Report to the Future Melbourne (Planning) Committee

**Planning Permit Application: TP-2015-906
88 Park Street South Yarra**

DELEGATED PLANNING APPLICATION REPORT

Application number:	TP-2015-906
Applicant:	George Nedovic
Address:	88 Park Street, SOUTH YARRA VIC 3141
Proposal:	Demolition of the existing dwelling and construction of a new two storey dwelling
Date of application:	7 October 2015
Responsible officer:	Oh Young Lee

TITLE SHADOW DIAGRAMS 9am, 10am

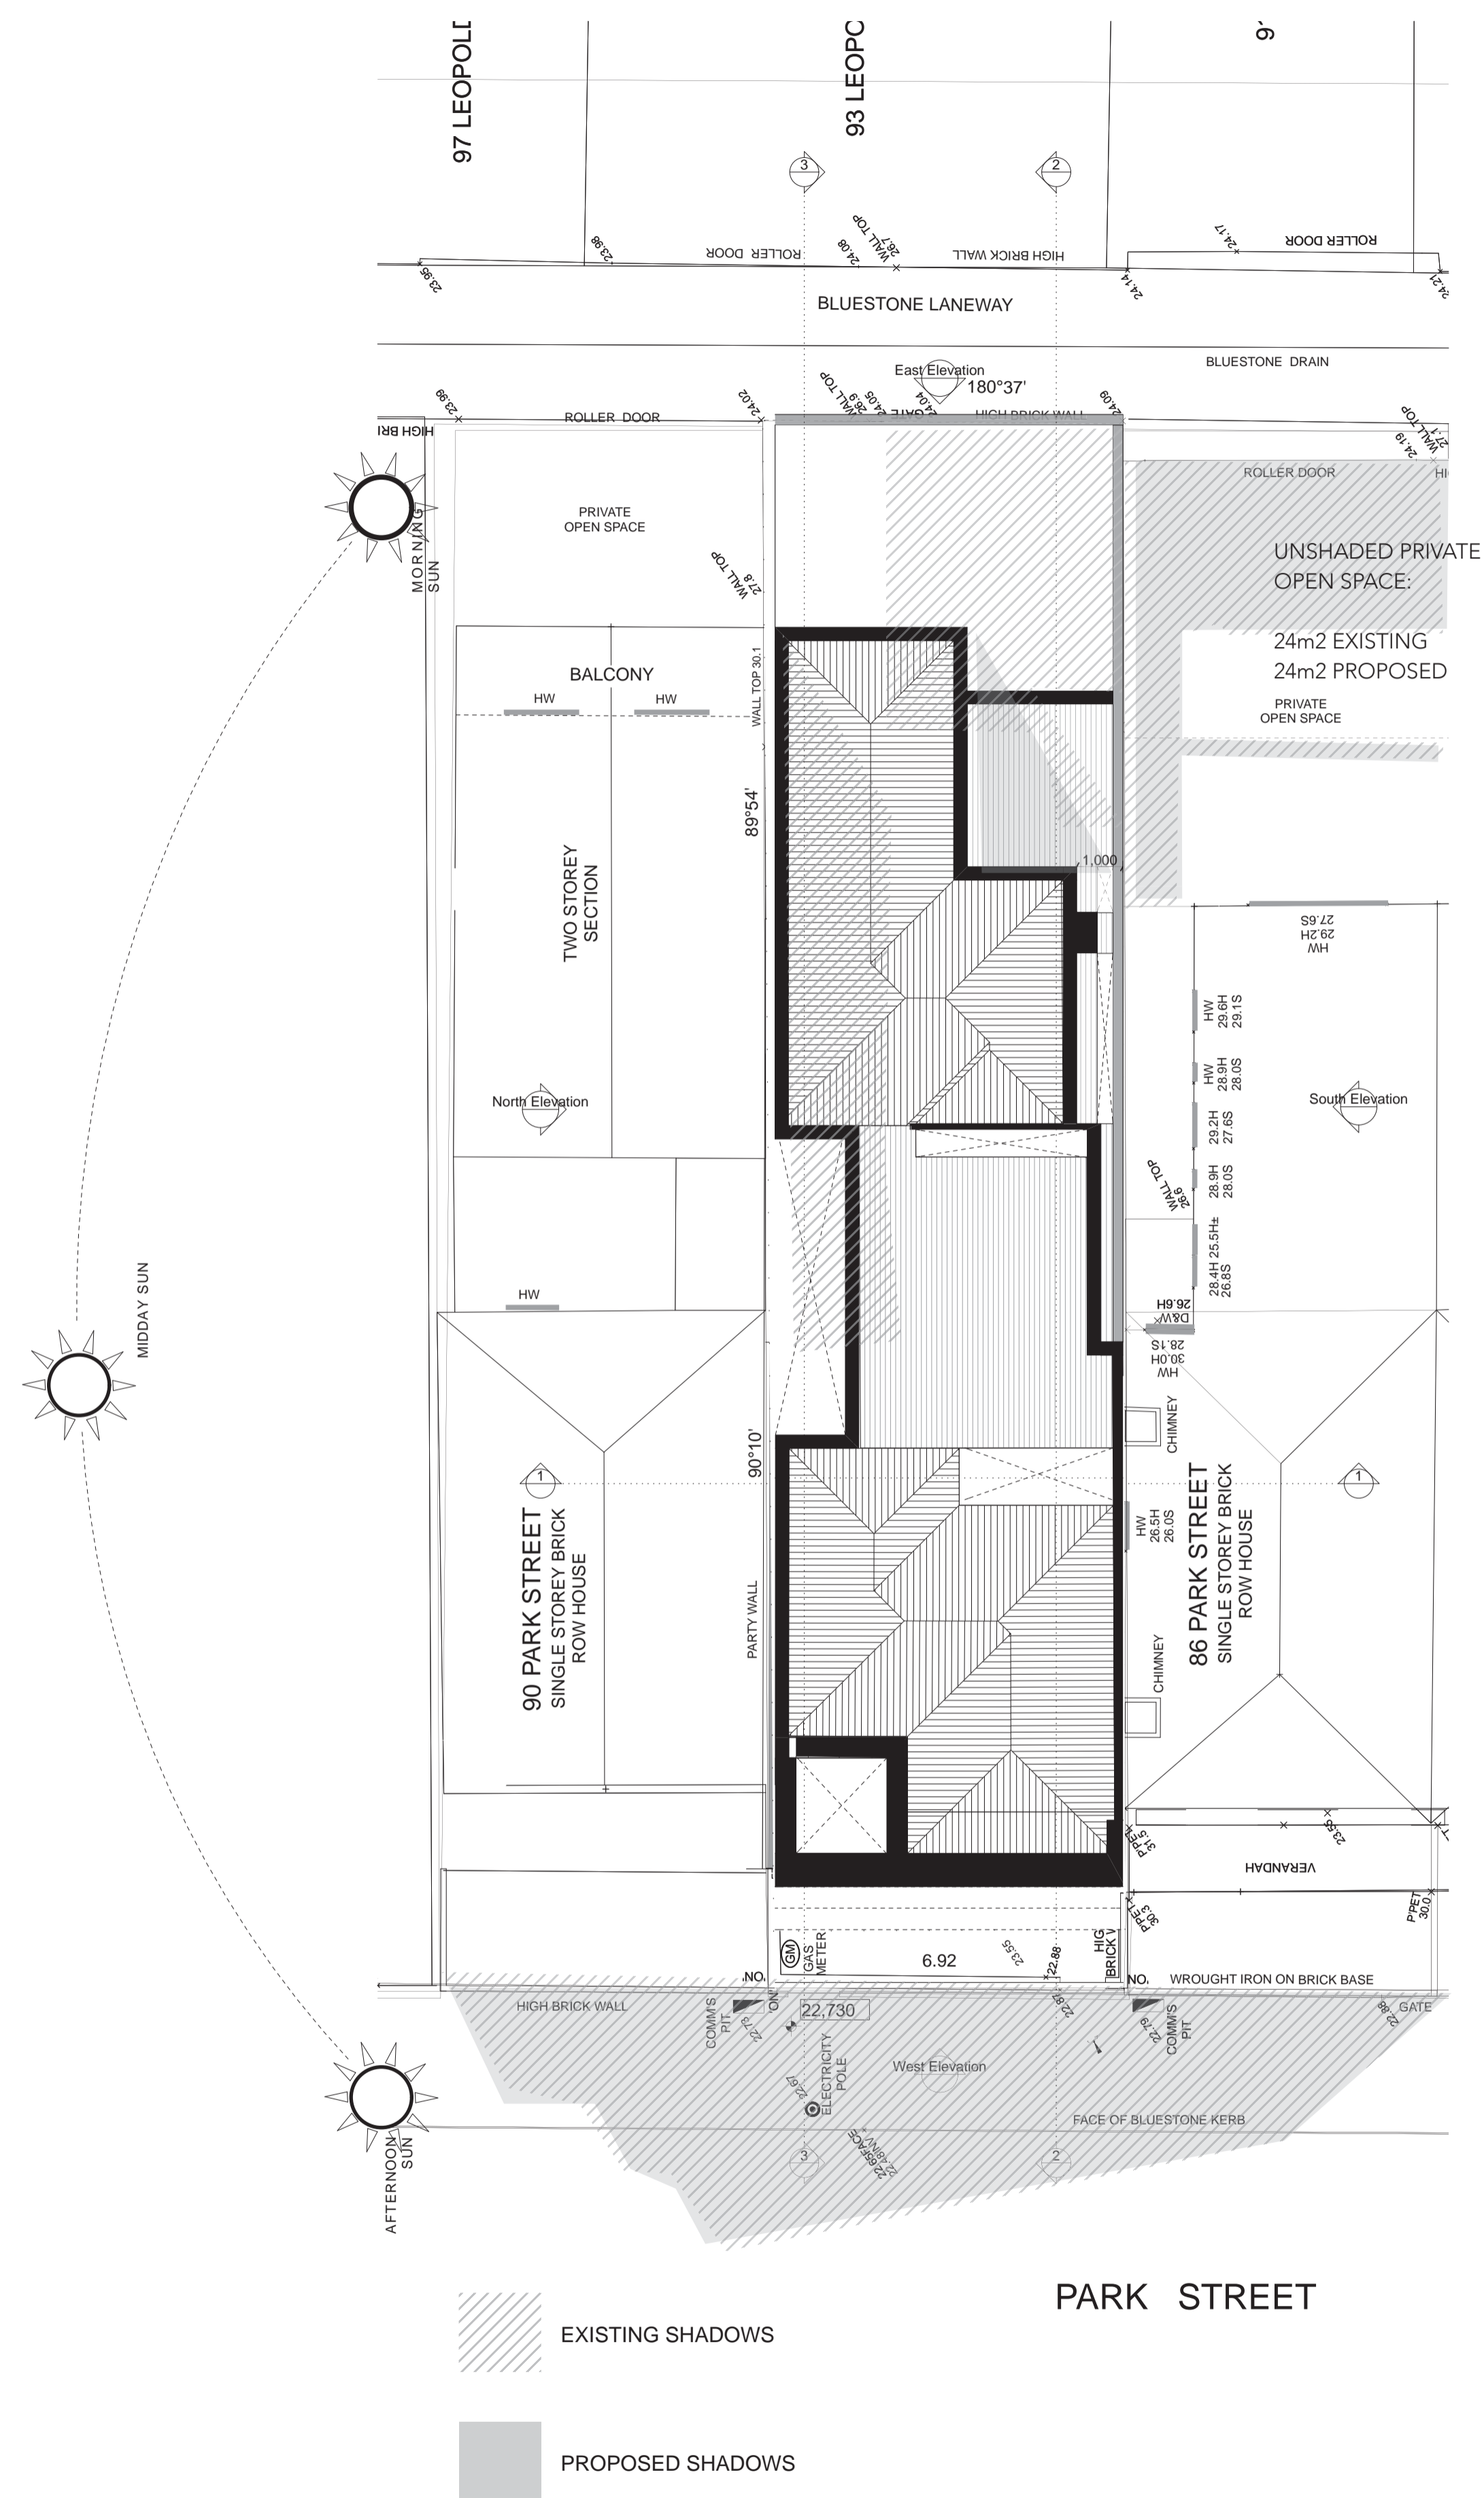
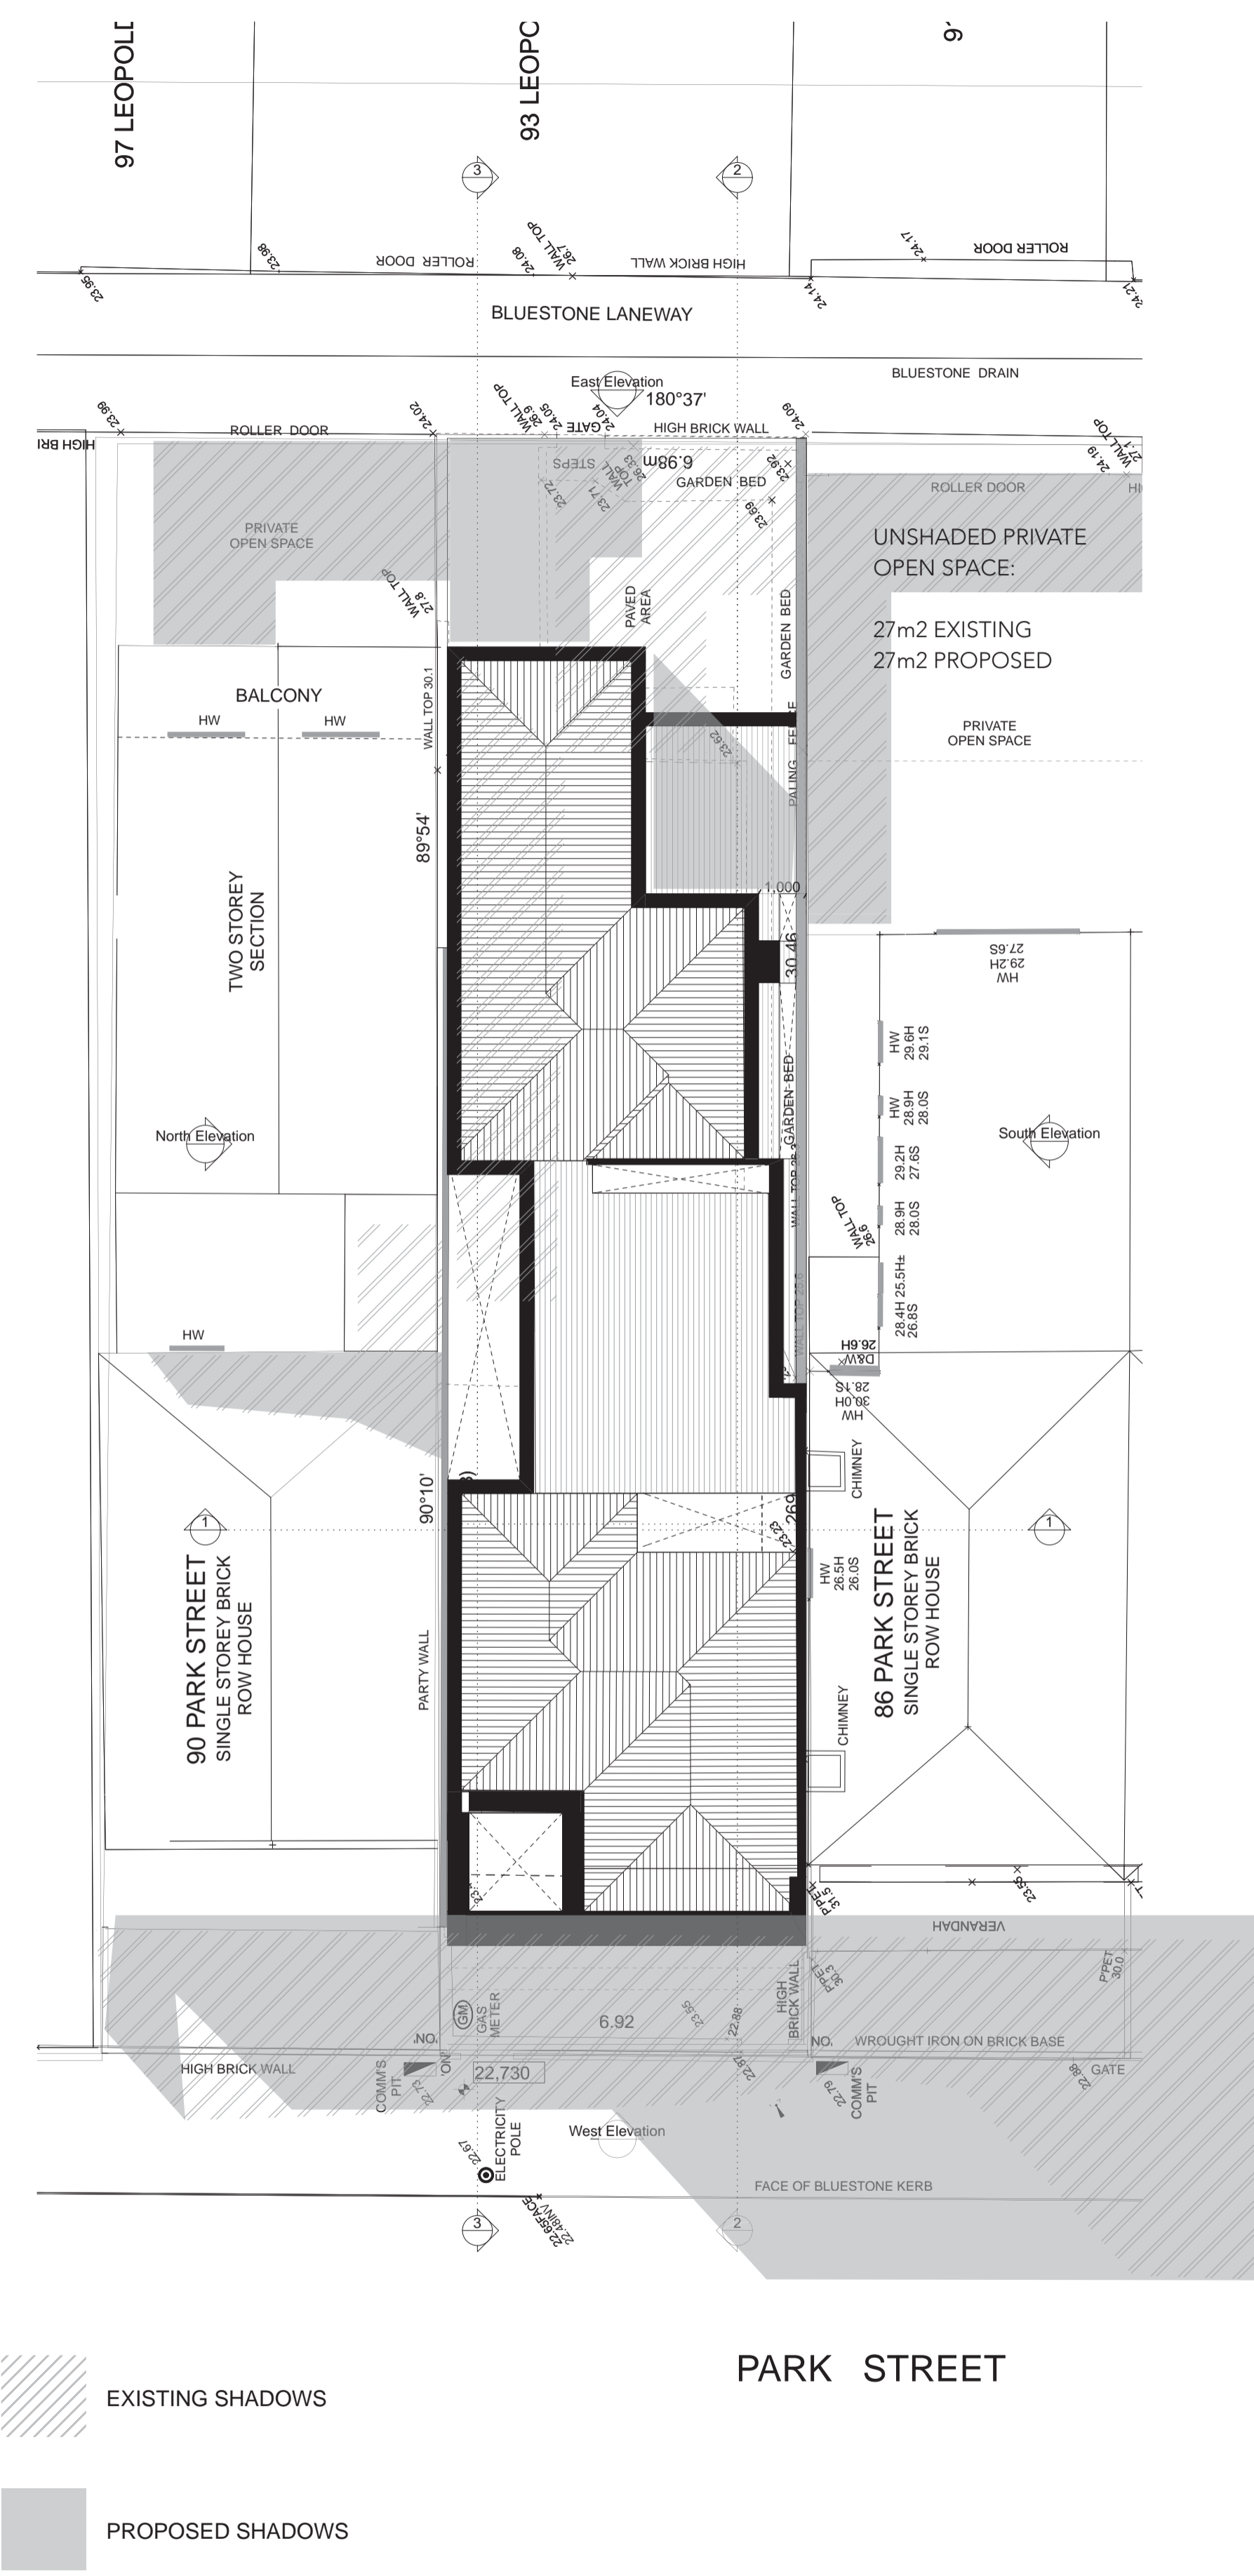
Overall it is considered that no adjoining property will be unreasonably impacted. It is also noted that the shadow diagram provided by the applicant is not reflective of the agreed setback of 1 metre to first floor bathroom and laundry, hence the impact depicted on these plans is likely to be reduced further as a result of this change.

- The existing light court and the skylight which may experience some of shadow from the proposal (although it is unclear from the shadow diagrams) are already overshadowed partially by the existing vegetation along the southern edge of the subject site.
- The applicant has agreed to a condition to provide a minimum 1 metre setback to the first floor walls located adjacent to these skylights, which would further reduce the impact.
- The objective and standard for overshadowing refers to impact on *secluded private open space*, not habitable room windows or private open space.
- It is also noted that the family room has access to daylight through full width glazing directly open to the private open space at the rear of the property and the existing skylight is not the only source of daylight to this room.
